1.0 APPLICATION SUMMARY

Applicant: Brookfield Properties
 FLU Category: SMU-6
 Service Area: Urban
 Site Acreage: +/-5 acres
 Community Plan Area: Apollo Beach
 Overlay: None
 Request: Minor Modification to PD 14-0815

Proposed PRS 24-0633: The proposed minor modification requests to amend a portion of the approved zoning limited to Folio 054156.2000 and a portion of Folio 054166.5416. The location of the property is within the Waterset DRI south of Paseo Al Mar Blvd. on both sides of Covington Garden Dr. The applicant proposes to transfer/exchange existing commercial entitlements from +/- 2.5-acres designated Mixed Use-Commercial (“MU-C”) to +/- 2.5-acres designated Residential/School. Specifically, the portion of Folio 054166.5416 subject to this minor modification (“Tract 9B”), would be designated as Residential (“RES”), and Folio 054156.2000 (“Tract 9A”) would be designated MU-C. The re-designation of the two 2.5-acre tracts does not result in a change in overall entitlements at the intersection of Paseo Al Mar Blvd. and Covington Dr. and would be a neutral exchange for entitlements purposes. In alignment with this PRS, the applicant proposes a concurrent amendment to the Wate

2.4 Existing Site Plan (Partial)

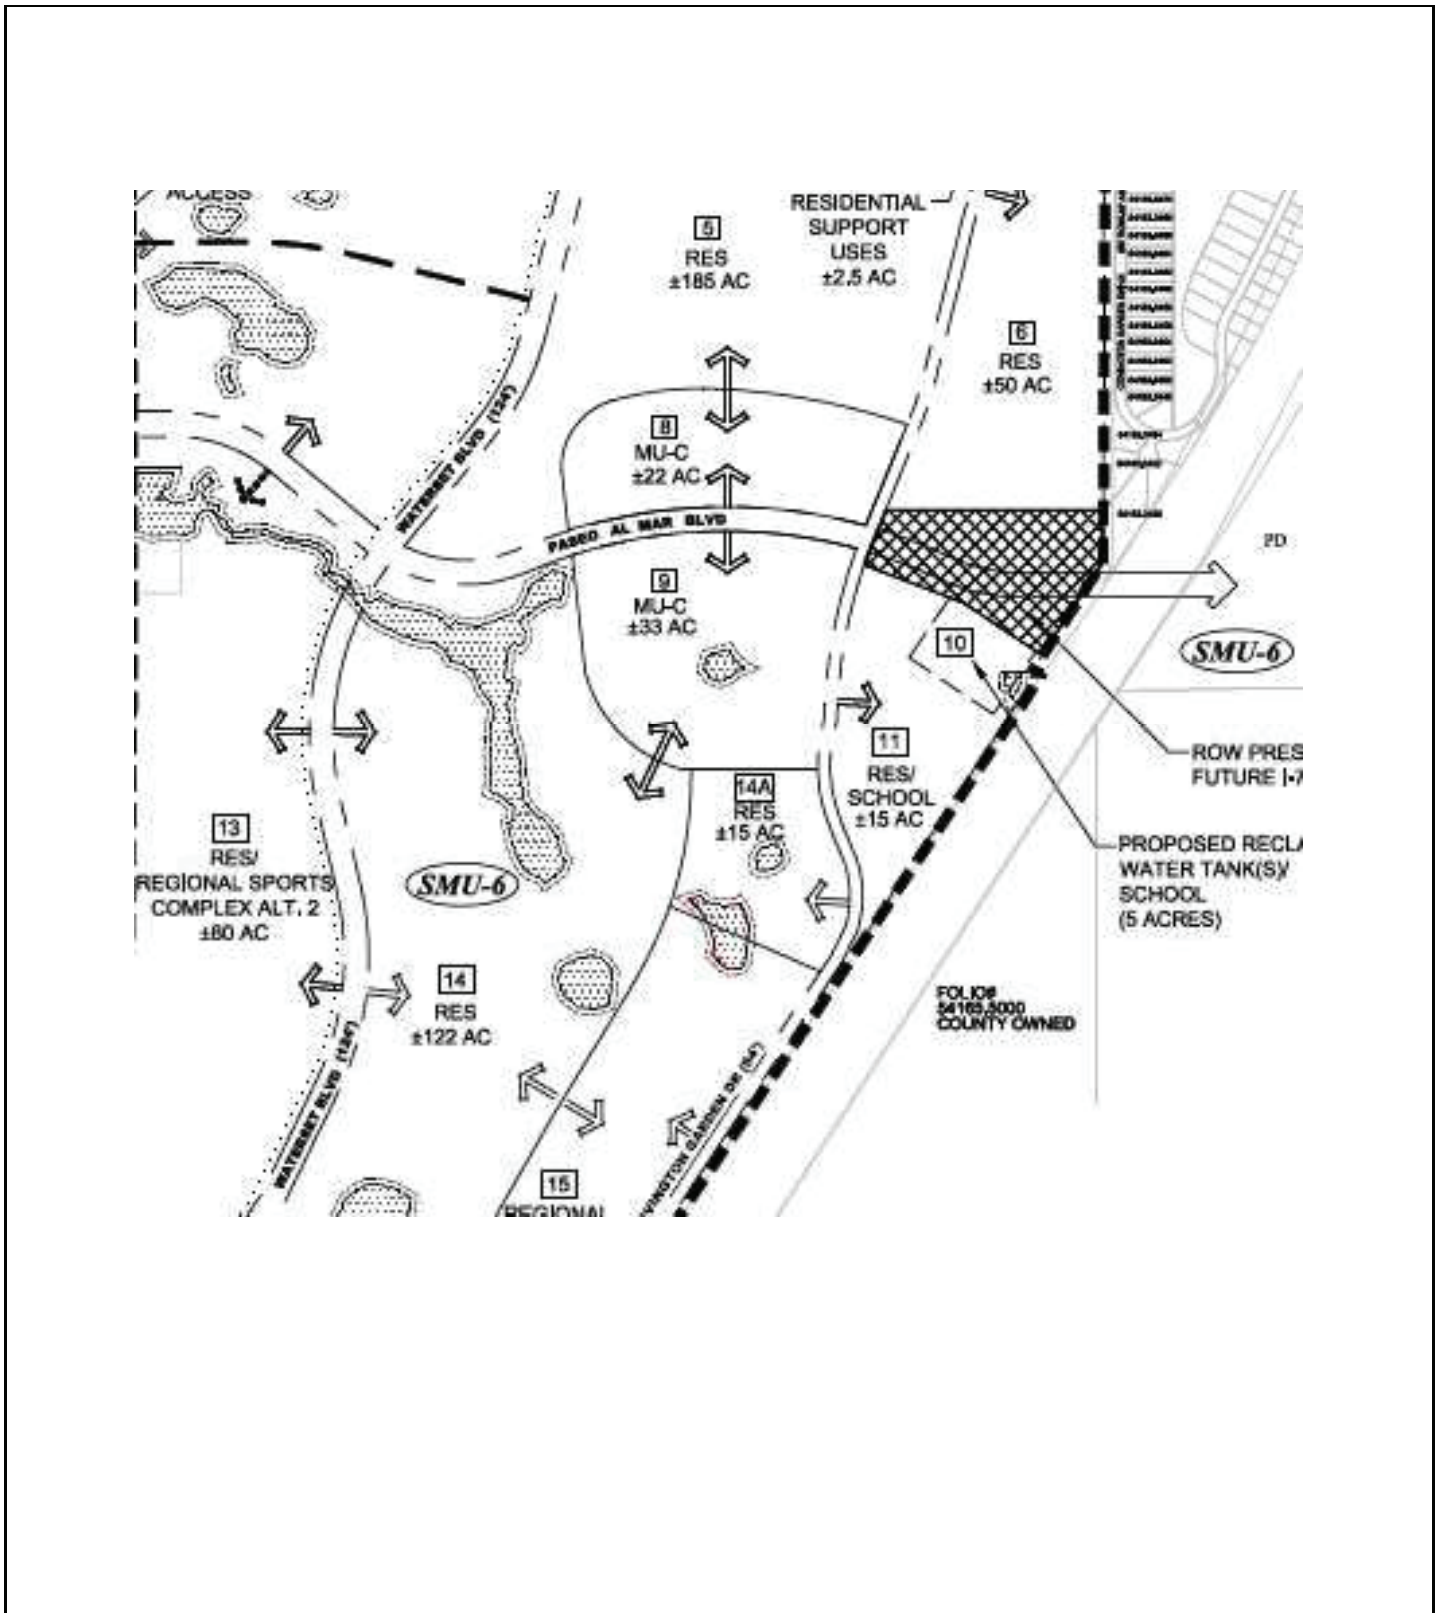
Existing Approval(s):	Proposed Modification(s):
(1) PD Site plan includes Tracts 9 and 11.	(1) Modify the PD General Site Plan to include two +/- 2.5-acre parcels carved out of Tracts 9 and 11 to be designated as Tracts 9A and 9B.
(2) Tract 9 is +/-33 acres.	(2) Reduce Tract 9 by +/-2.5 acres per creation of Tract 9B as an MU-C tract. Tract 9 would be reduced to +/-30.5 ac.
(3) Tract 11 is +/-15 acres.	(3) Reduce Tract 11 by +/-2.5 acres per creation of Tract 9B as a Residential Tract (outside of Town

2.5 Proposed Site Plan

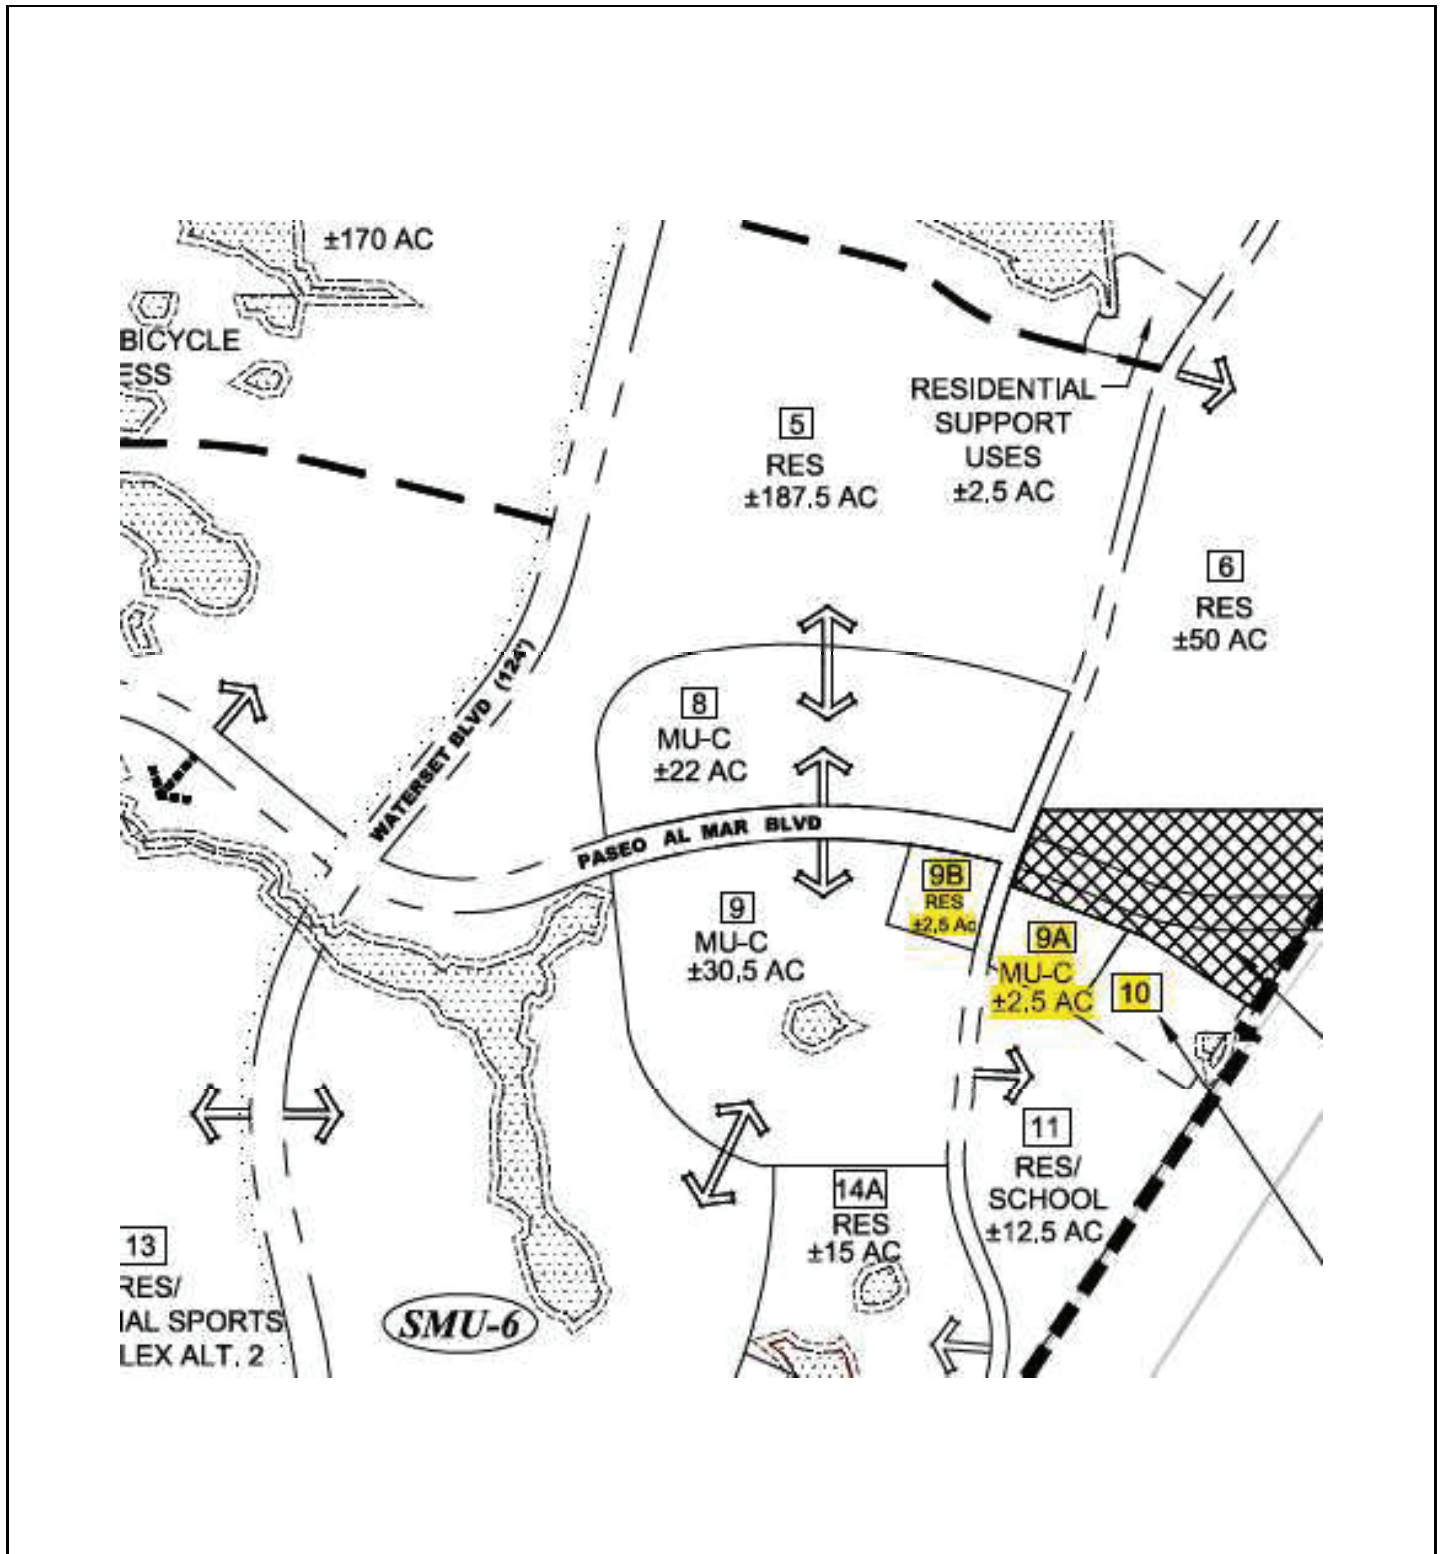
- The developer shall revise the PD site plan to modify the Land Use Schedule to add a foot note below which applies to the Mixed Use – Central area. The footnote shall state “Tract 9A uses are further restricted pursuant to a transportation trip cap – see conditions of approval.”
- The applicant shall remove the highlight on Tract 10.
